**Re: Harnett County Land Use Application HTE #08-5-21354**

UPDATED PLOT PLAN  
 235 PAPOOSE TRAIL  
 LOT 35  
 CHEROKEE RIDGE  
 HARNETT COUNTY, NC

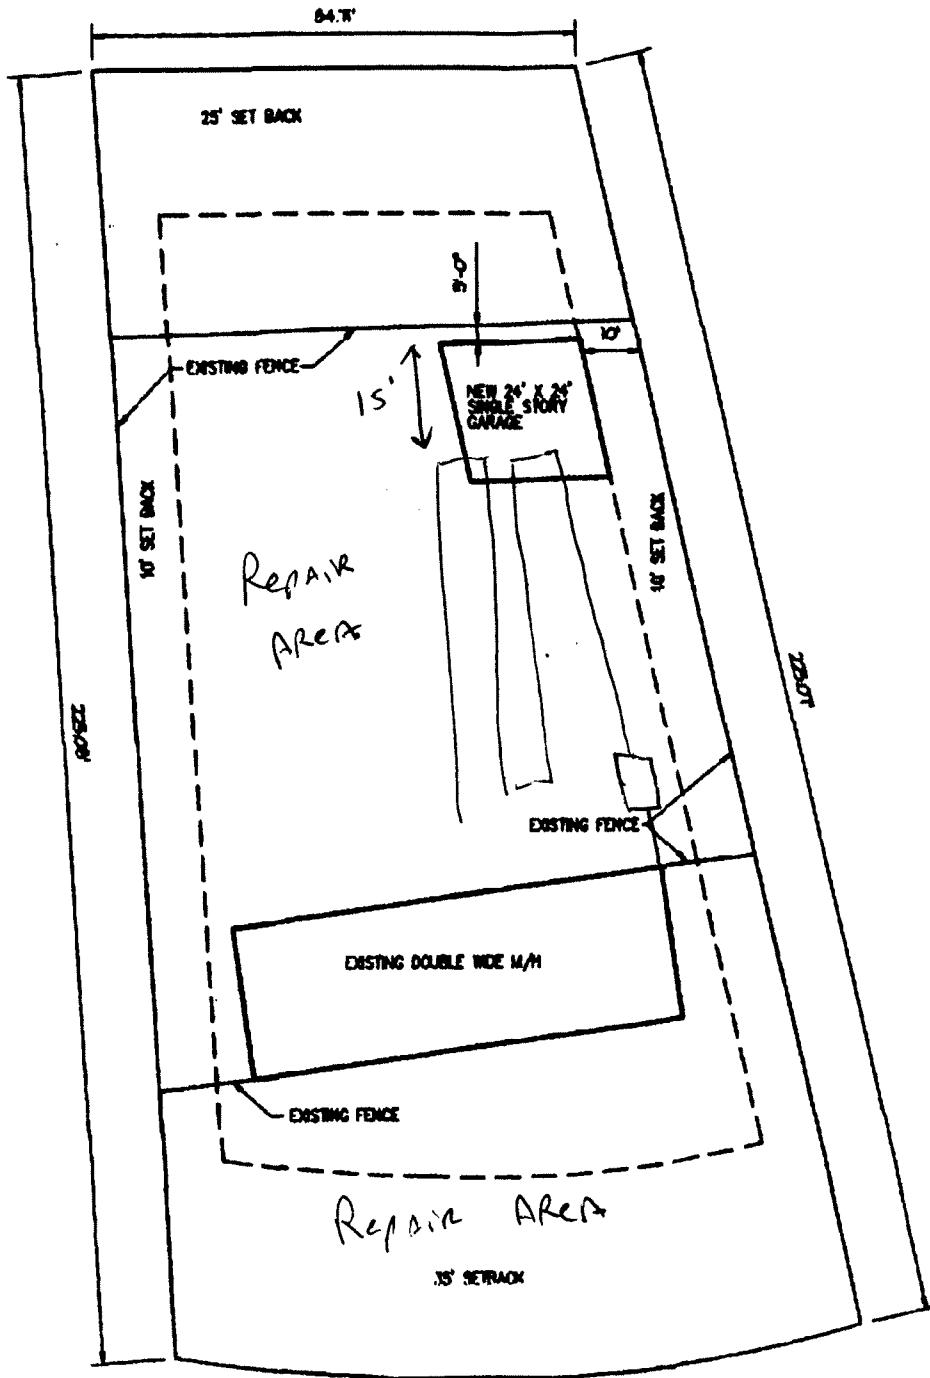
Based on the criteria set out in Title 15A, Subchapter 18A, of the North Carolina Administrative Code, Rules .1950, the evaluation indicated that the site is **UNSUITABLE** for the addition requested. Therefore, your request for an existing tank is **DENIED**. The site is denied based on the following:

**15A NCAC 18A.1950 a(16) Any swimming pool must be 15' from any part of septic system.**

**15A NCAC 18.1945 (b) Each lot shall have original septic system plus repair area.**

**15A NCAC 18A.1950 (10) – Any building to be 5' from drain line.**

***The garage is staked out on top of the drain field. (See the attached map showing approximate drain field and repair area location.)***
